S E R V I C E N O T E

8131A Programmable Pulse Generator

A1 / 8131-66501 / BD AY KEY, Std.

Solution to eliminate crosstalk to the output signal**To Be Performed By:** Agilent-Qualified Personnel**Parts Required:**

A1 Component Side, left upper corner

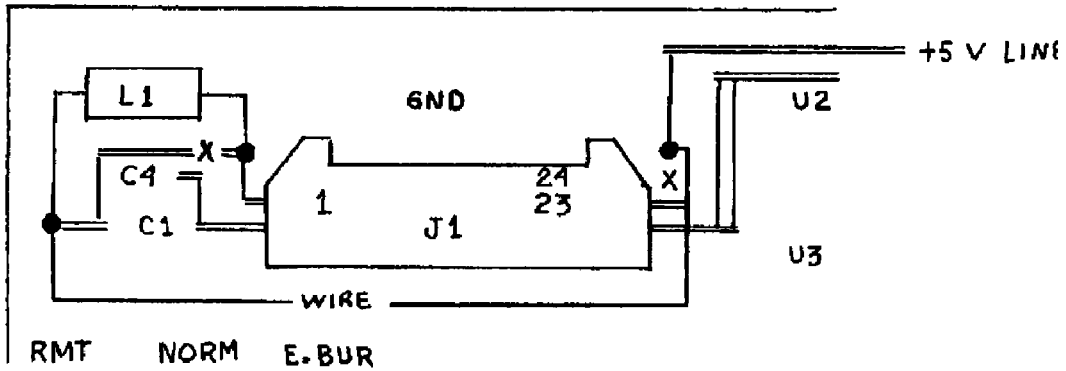
In the instruments with the serial numbers shown above, the display driver may influence the output signal. This results in spikes of about 10 mV.

To solve the problem the Key/Display Board has to be modified. Follow the instructions shown below.

Part No.	Description	Reference Designator
9140-0748	L-FXD 250uH	A1L1

Cut the +5 V line at the shown points (X)

Solder the WIRE and/or L1 to the shown points (●)
